Access Compliance Report Public Rights-of-Way (Curb Ramps)

Main Street: FOSTER_RD		Cross Street: PIEDMONT_AVE		Location:	W
ADA ID: RPAT211206113418	Ramp Type:Type 1 - Perpendicular Diagonal Initial Pass/Fail: Pass		Overall Compliance: No	Severity Score:	0
Codes/Mitigation Info/Possible Solution			Field Measurements/Component Compliance

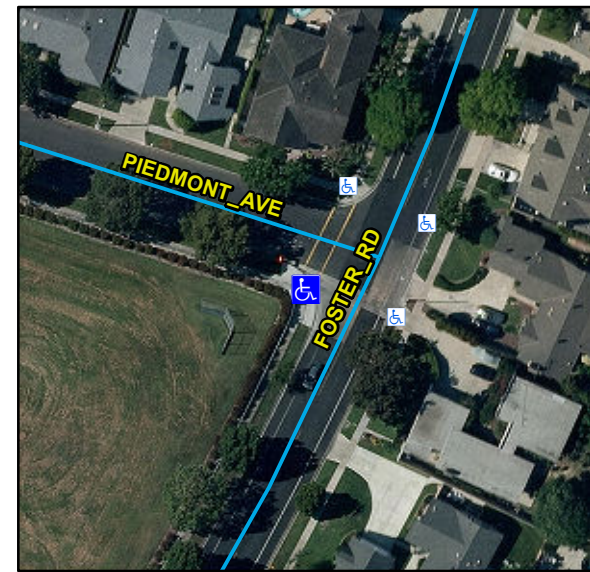
R304.2.2, R304.2.1, R304.2.2-Perp, R304.3.2-Para, R302.7, STD 1115

Remove & Replace Curb Ramp With Two New Directional Ramps or Equivalent.
